Status B
Submittal was reviewed for design conformity and general conformance with the design intent only within the remit of an architect. The sub-contractor is responsible for confirming and correlating dimensions at job sites for tolerances, clearances, quantities, fabrication processes and techniques of construction, safety, coordination of his work with other trades and full compliance with the contract documents. The review shall not be construed to mean acceptance of the detail design inherent in the drawing, responsibility for which will remain with the sub-contractor. The sub-contractor is responsible for any errors or omissions in the drawing and for meeting all the requirements of the contract documents or otherwise.
Conran and Partners 06/07/16

DOCUMENT REVIEW Brookfield MULTIPLEX BM

CLIENT: RAPHAEL CONTRACTING LTD
PROJECT: CENTRE POINT, 103 NEW OXFORD ST.
SCALE: 1-10,1-5 & 1-1. DATE: 21-11-2015
DRAWN BY: AJG CHECKED BY:
DRAWING TITLE: Apartment type 8,Penthouse Bathroom Type B,Room 11.Vanity Unit Type A, level 33.
PROJECT No: 6538 REVISION: -
DRAWING No: E1003-81-CPT-XX-131
DRAWING STATUS: FOR APPROVAL

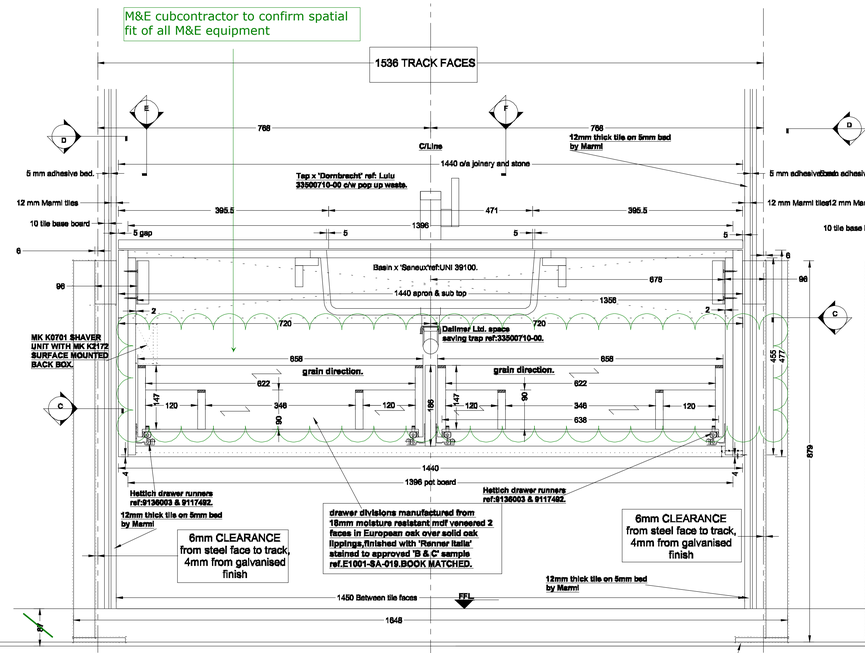
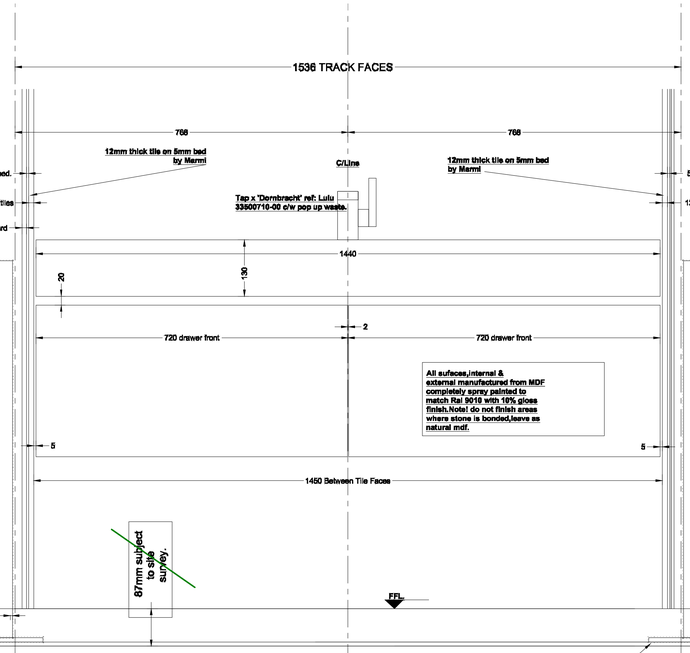
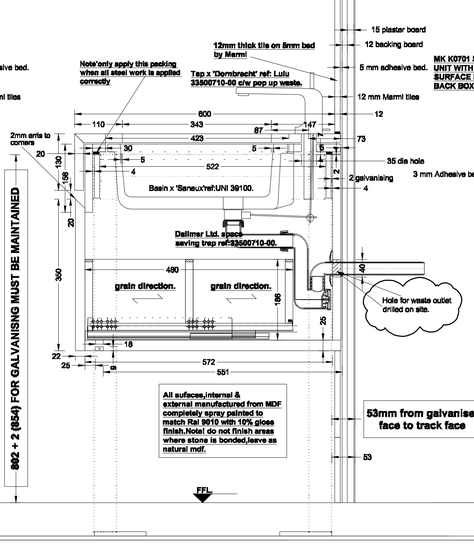
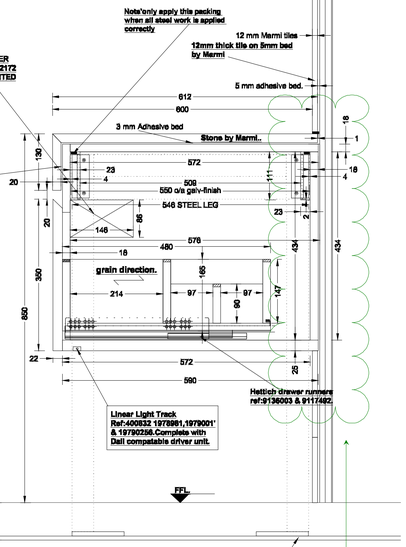
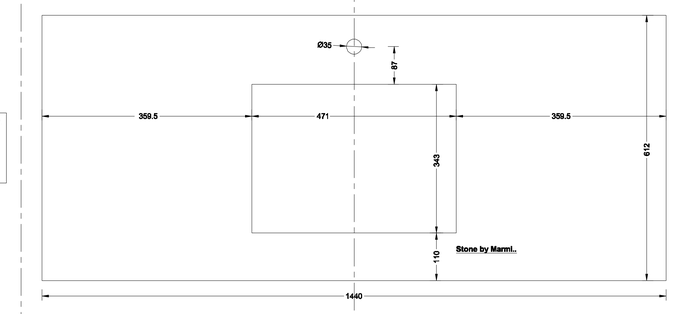
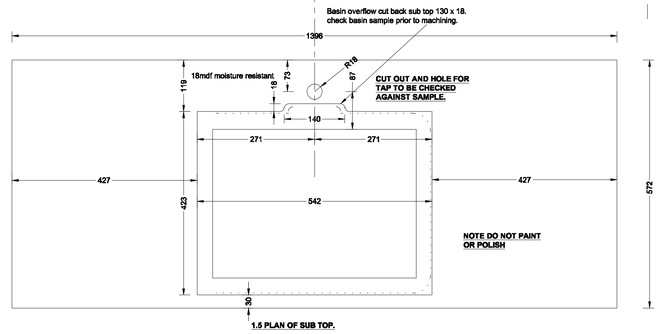
C&P reserve the right to add additional comments to these drawings at a later stage as these drawings were submitted for review, prior to formally agreed C&P design period. As such C&P have not commenced works on the areas related to these drawings and cannot review and comment in full.

NOTE: -
1. HOLE FOR WASTE FROM WHB THROUGH VANITY UNIT TO BE COORDINATED WITH SEVICE INSTALLATION
2. HOLES FOR HOT & COLD WATER SERVICES REQUIRED. THIS WILL ALSO NEED TO BE COORDINATED WITH OTHER SERVICES AND PENETRATION REQUIREMENT
3. PLEASE REFER TODRG- E1003-81-CPT-XX-127 REV 01 FOR OTHER COMMENTS

Incorporate comments and resubmit drawing following release of Level 33/34 survey and architectural 'For Construction' issue drawings.
